THM 700-R4 "UPDATE HANDBOOK"

AUTOMATIC TRANSMISSION SERVICE GROUP

Figure 39

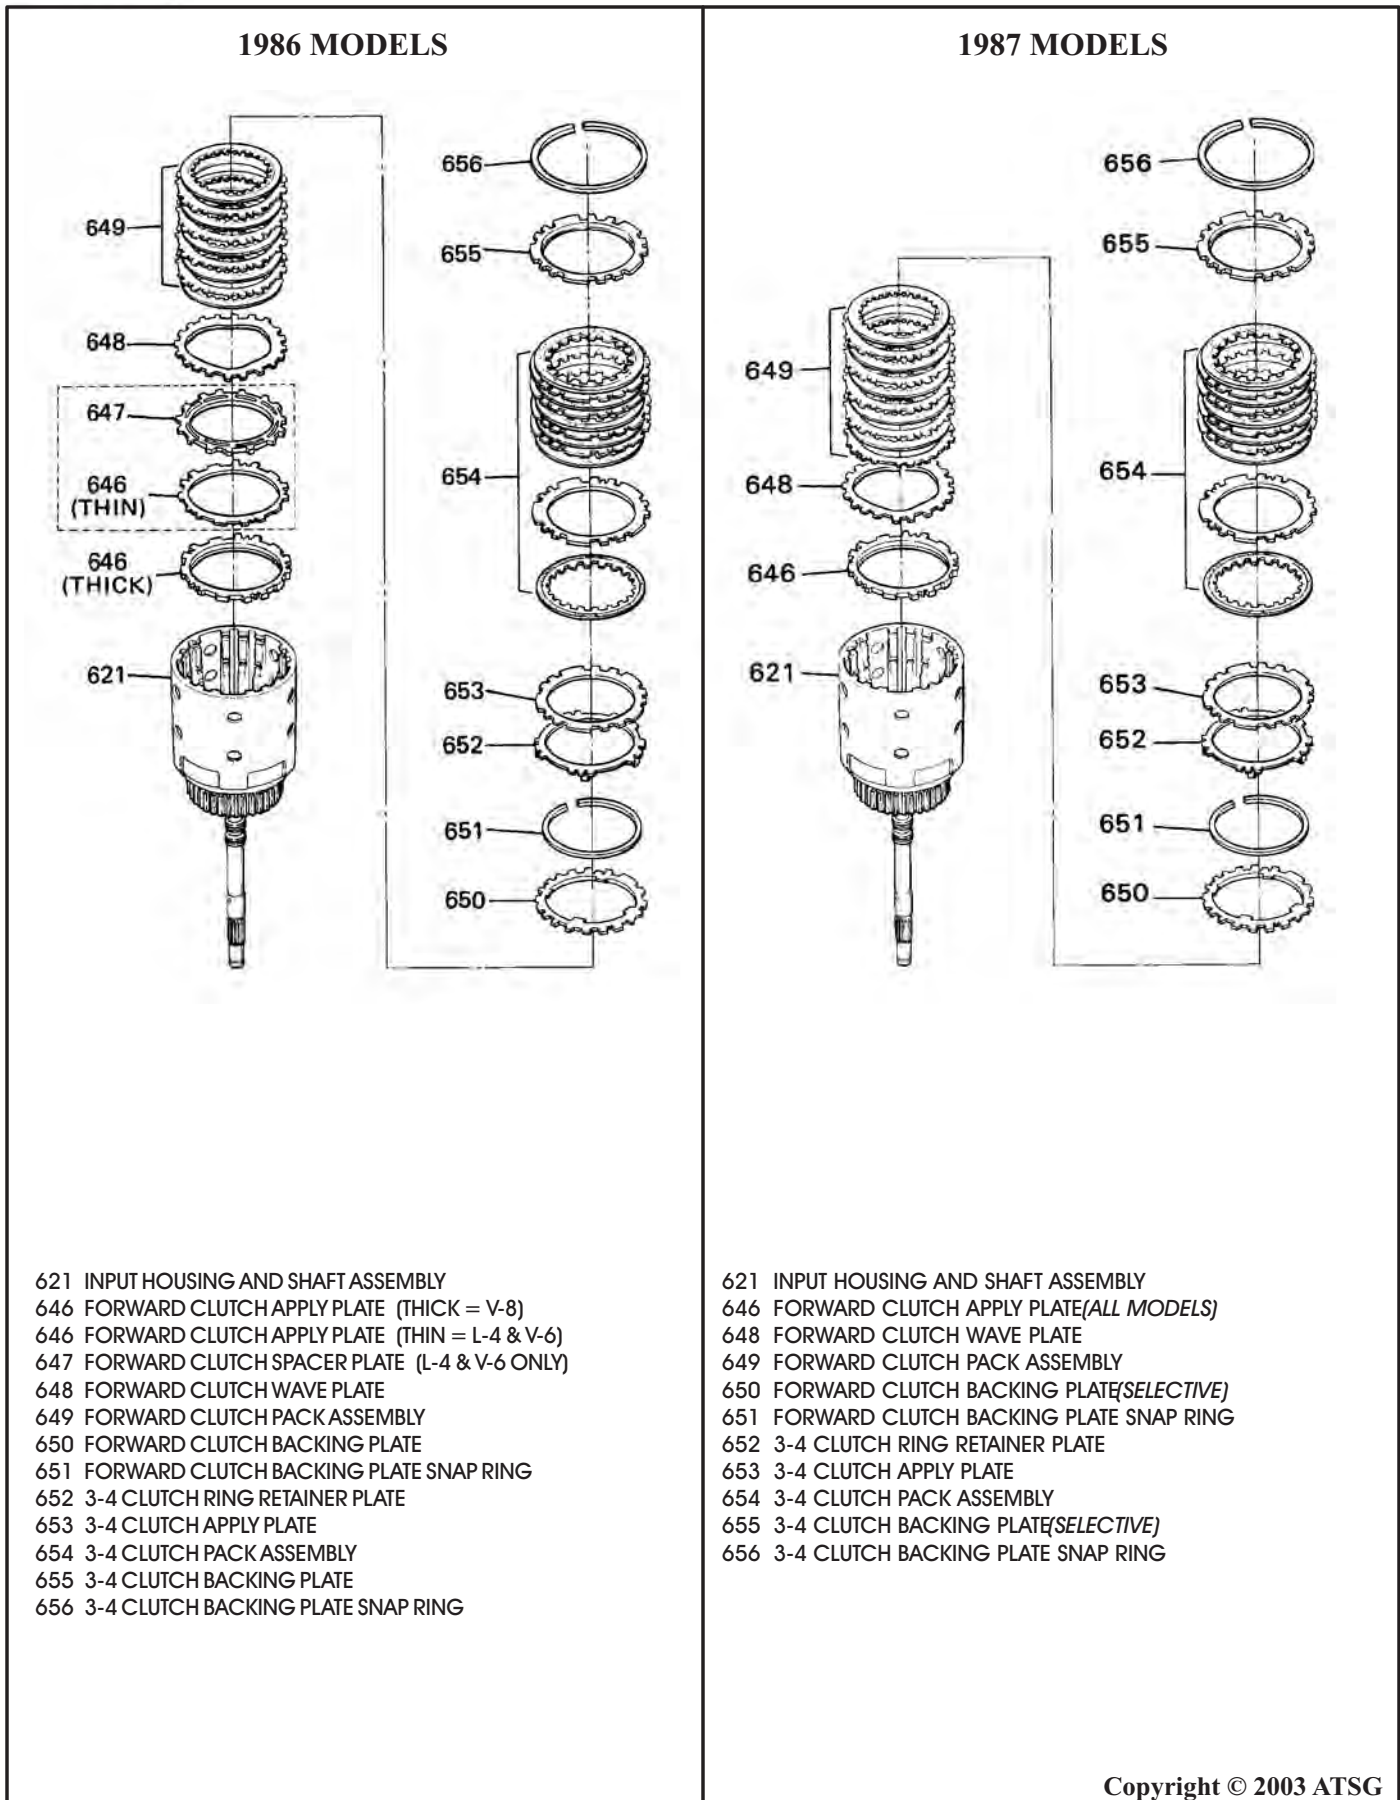
- (d) All models are now built with a forward clutch pack that has five lined plates, as shown in Figure 39. The new design lined and steel plates have a revised thickness, and the forward clutch backing plate is now selective, as shown in Figure 40. We have also listed the OEM Part Numbers for the selective Forward Clutch Backing Plates in Figure 40.

- (7) The forward clutch friction and steel plates are a different thickness in all 1987 and later models, and the forward clutch backing plate is now selective, as shown in Figure 39 and 40. When building an 82-86 unit, do not mix 87 style clutch plates with the 82-86 clutch plates without checking the forward clutch clearance (See Figure 40).

Figure 42

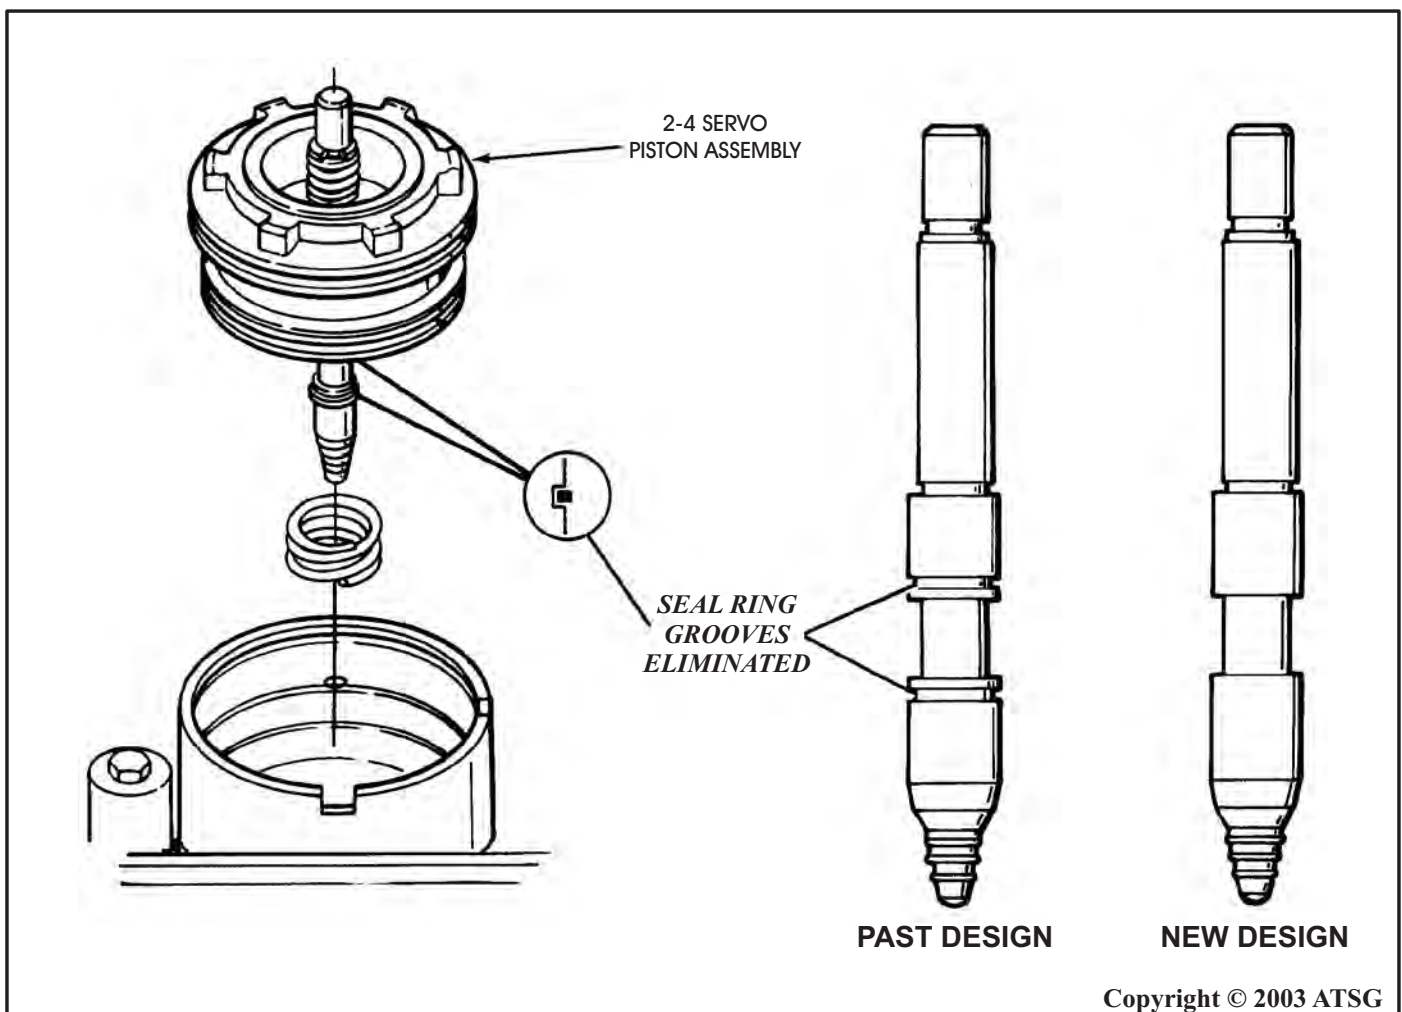
CHANGE: Beginning on January 5, (Julian Date 005) 1987, there were changes to the 2-4 servo apply pin that eliminated the two seal rings, and the seal ring grooves in the pin (See Figure 42).

- (1) 2-4 SERVO PIN - Seal grooves eliminated in the servo apply pin, as shown in Figure 42. Testing has shown that any potential leakage in this area with the new servo pin will not affect transmission performance or durability.

Servo Apply Pin, 2 Ring I.D, 66.37-66.67mm (2.610" - 2.620")	8667571
Servo Apply Pin, 3 Ring I.D, 66.74-66.04mm (2.670" - 2.680")	8667572
Servo Apply Pin, Wde Band I.D, 69.11-69.41mm (2.720" - 2.730")	8667573

Figure 43

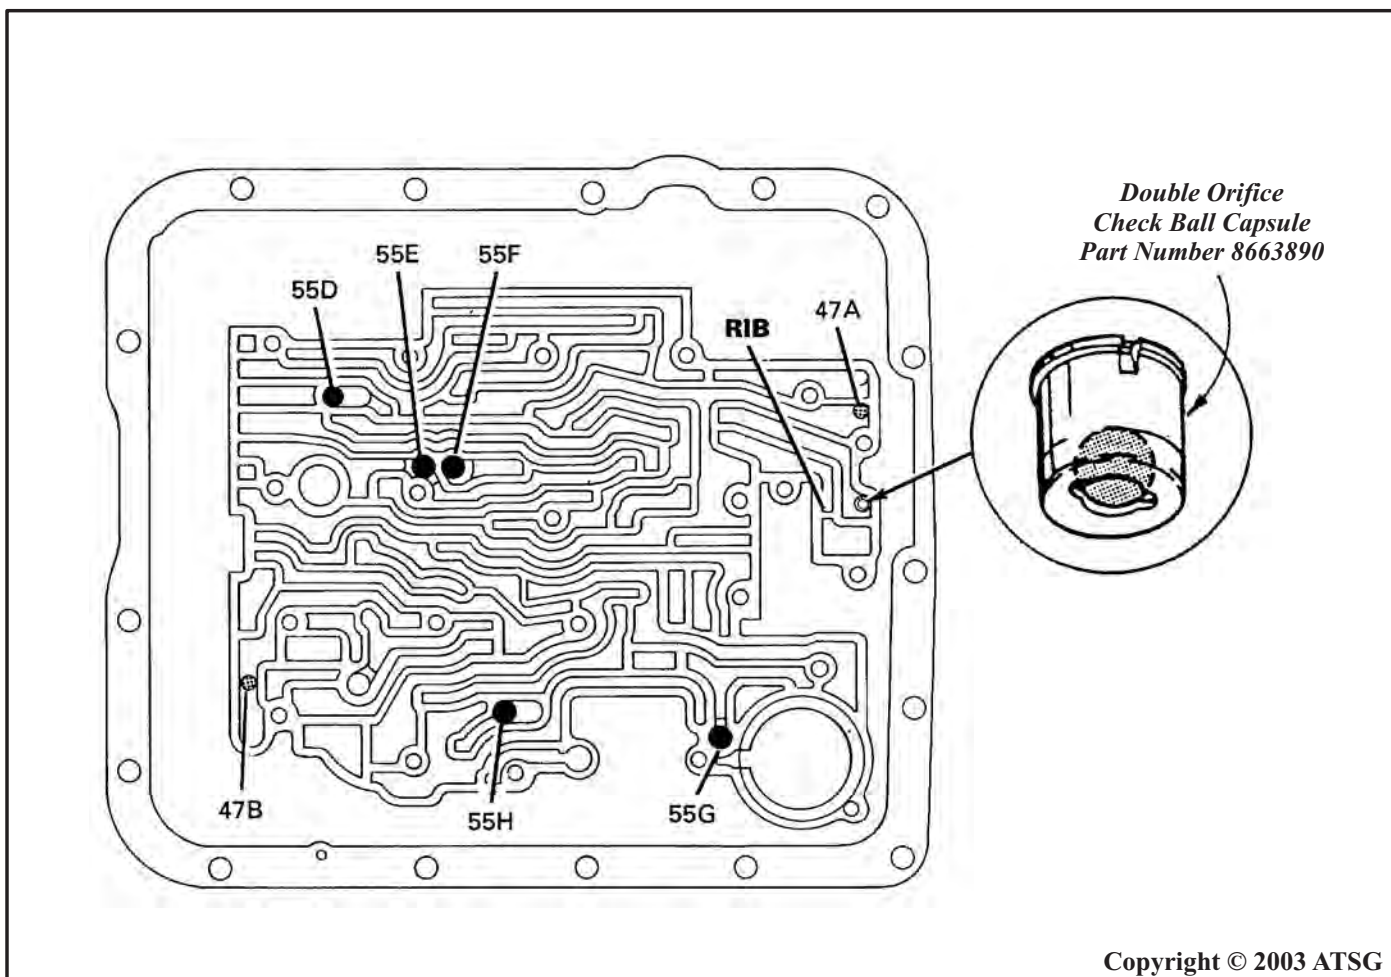
CHANGE: Beginning on February 9, (Julian Date 040) 1987, there was a double orificed ball capsule added to the Low/Reverse passage in rear of case, as shown in Figure 43. This capsule was part of a Reverse apply package that was implemented at the same time.

- (1) ORIFICED CHECKBALL CAPSULE - Added to the low/reverse passage at the rear of the case in the location shown in Figure 43, which allows for both a controlled apply and a rapid release of the Low/Reverse clutch.

Double Orifice Checkball Capsule 8663890

Figure 44

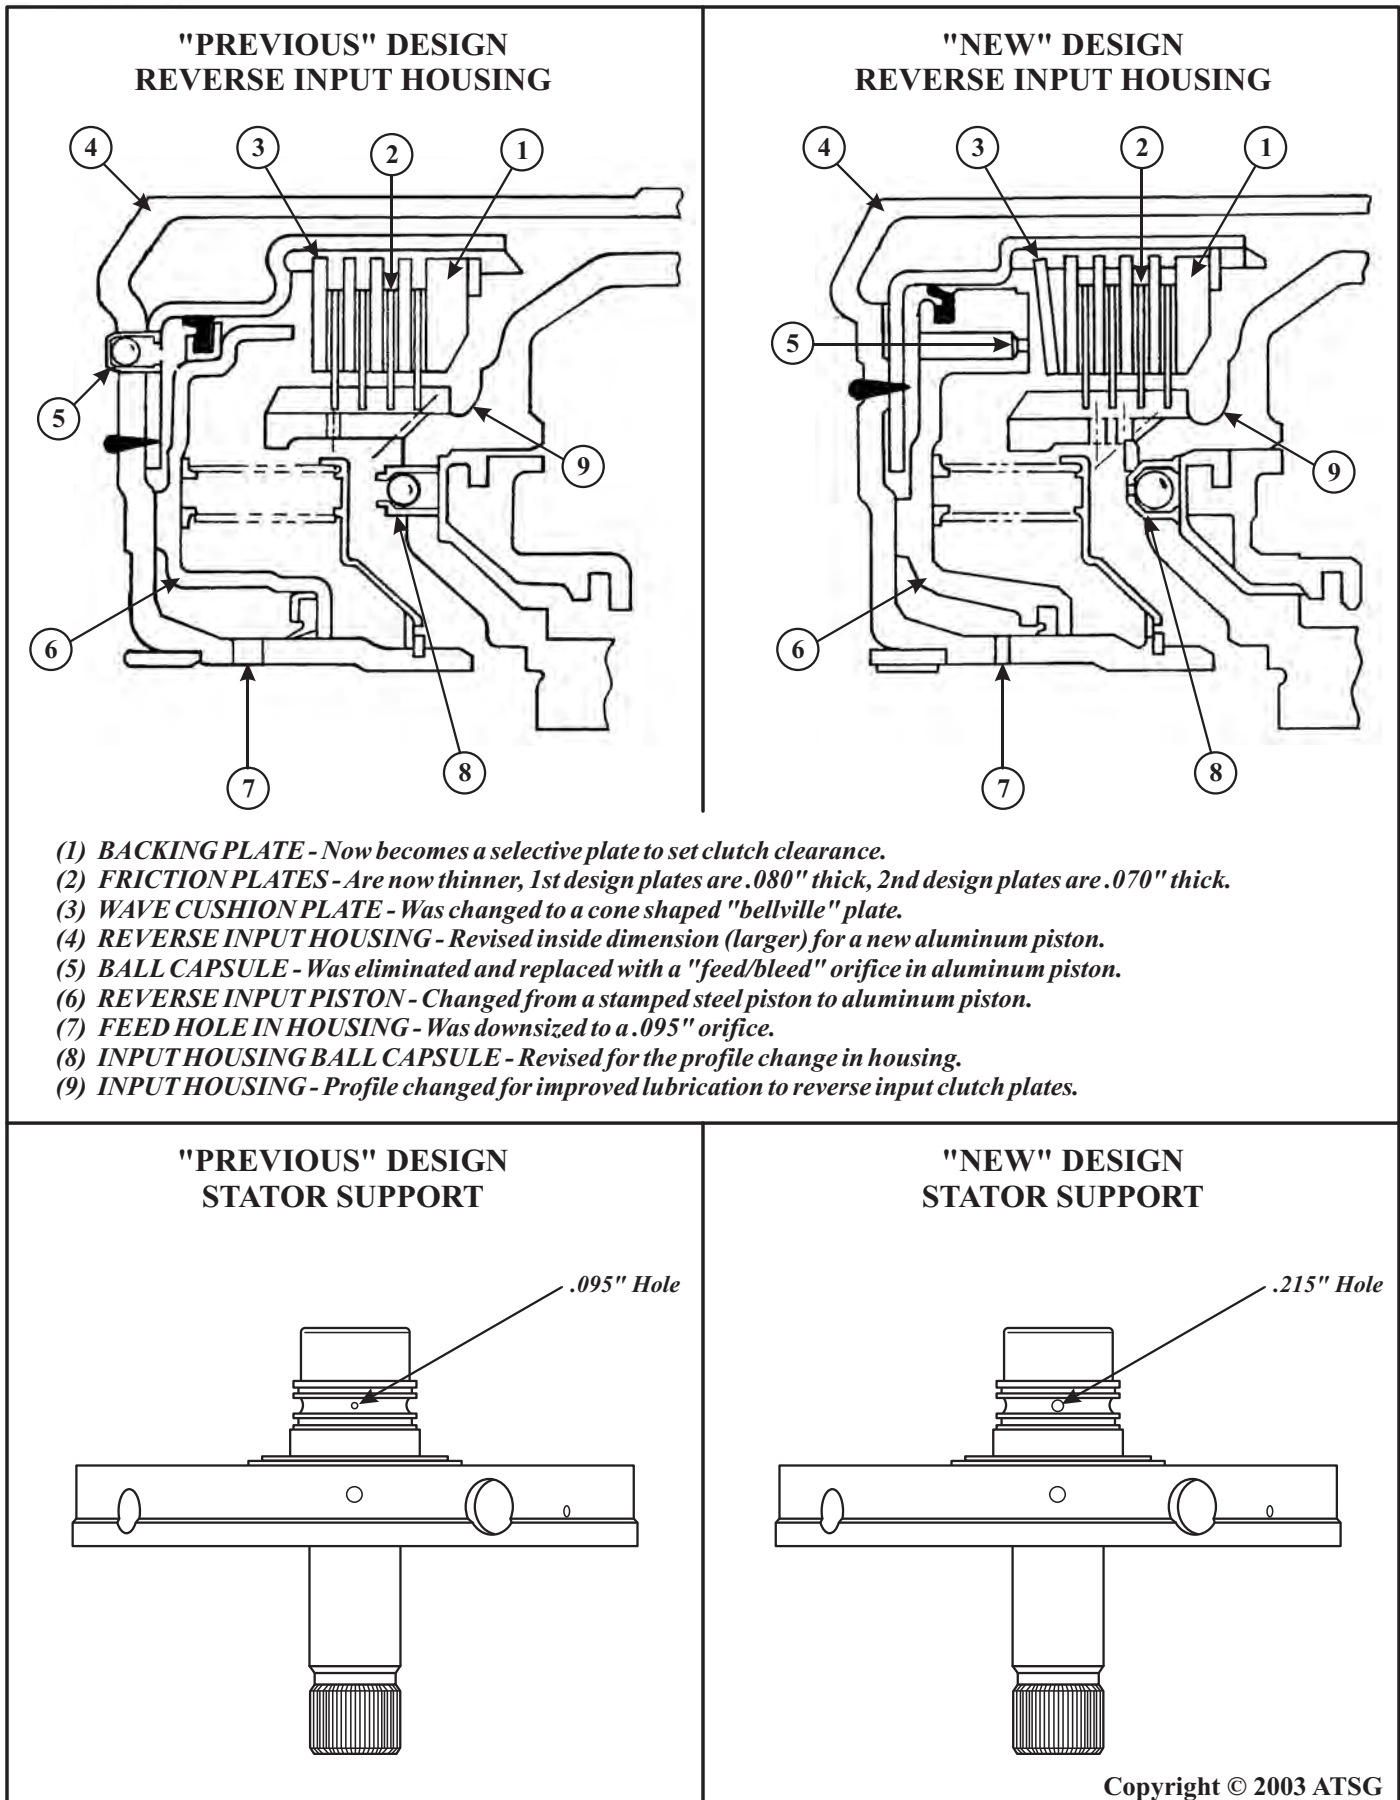
- (1) REVERSE INPUT HOUSING - Several changes occurred here and are as follows:
 - (a) The Reverse Input Housing has a revised (larger) inside dimension to accommodate the new larger aluminum reverse piston, as shown in Figure 44.

- (b) The feed hole on the inside diameter of hub in the housing is reduced to .095" diameter, as shown in Figure 44. Previous design has a .151" X .197" rectangular hole.

- (c) The air bleed "Ball Capsule" is eliminated from the reverse input housing and replaced with a .095" orifice hole in the new aluminum piston, as shown in Figure 44.

- (d) The reverse input piston changes from stamped steel to cast aluminum (See Figure 44).
 - (e) The reverse input piston lip seals revised to accommodate the new larger aluminum piston as shown in Figure 44.

- (f) The "Wave" plate is replaced by a cone shaped "Bellville" plate. The "Bellville" plate must be installed with the inside diameter against the steel plate, as shown in Figure 44.

- (g) The thickness of the friction plates change from the previous .080" thick, to the new .070" thickness, as shown in Figure 44, and the reverse input clutch backing plate is now selective, also shown in Figure 44.

- (2) OIL PUMP COVER - The reverse input feed hole between the sealing ring grooves has been enlarged to .215", where the previous was .095", as shown in Figure 44.

- (3) INPUT HOUSING - The profile of the input housing was changed where it mates with the reverse input clutch plates, as shown in Figure 44. This change provides improved lube to the reverse clutch plates, and also requires a revised dimension checkball capsule in the input housing, as shown in Figure 44.

Double Orifice Checkball Capsule	8663890
Low/Reverse Clutch Selective Plate (I.D. None)	8667592
Low/Reverse Clutch Selective Plate (Stamped "4")	8667593
Low/Reverse Clutch Selective Plate (Stamped "5")	8667594
Reverse Input Clutch Selective Backing Plate (Stamped "5")	8663075
Reverse Input Clutch Selective Backing Plate (Stamped "6")	8663076
Reverse Input Clutch Selective Backing Plate (Stamped "7")	8663077
Reverse Input Clutch Selective Backing Plate (Stamped "8")	8663078
Reverse Input Clutch Selective "Bellville" Plate	8663074
Reverse Input Clutch Aluminum Piston (.095" Orifice)	8663071

Figure 45

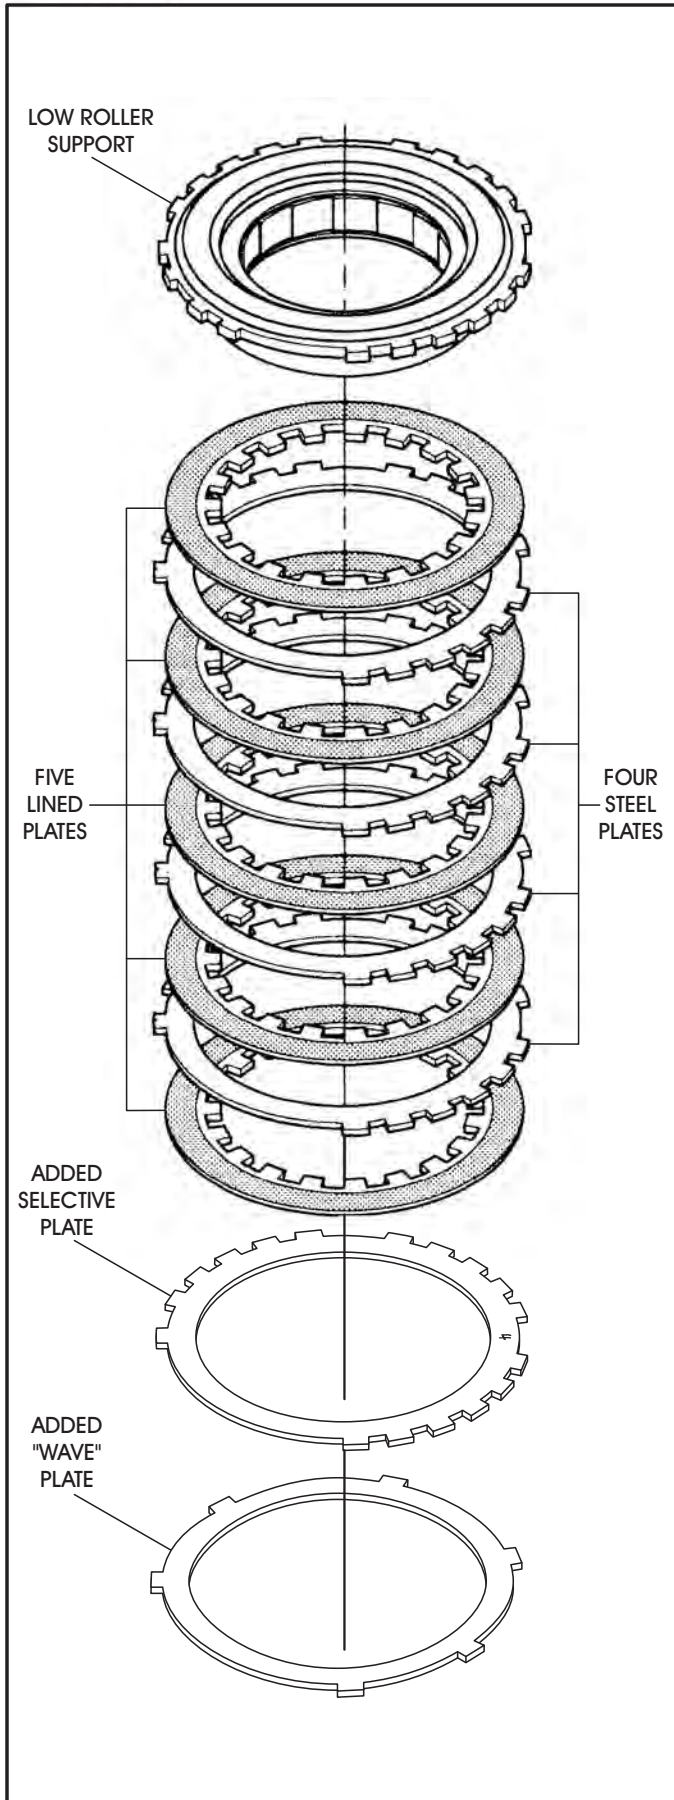
- (4) LOW/REVERSE CLUTCH PACK - Has an added "Wave" plate to help cushion the apply, and an added "Selective" plate to set clutch clearance, as shown in Figure 45. All models now use 5 frictions, 4 steels, 1 "Selective", and 1 "Wave" plate.
To Choose The Proper "Selective" Low/Reverse Clutch Plate, See Figure 47 and 48.
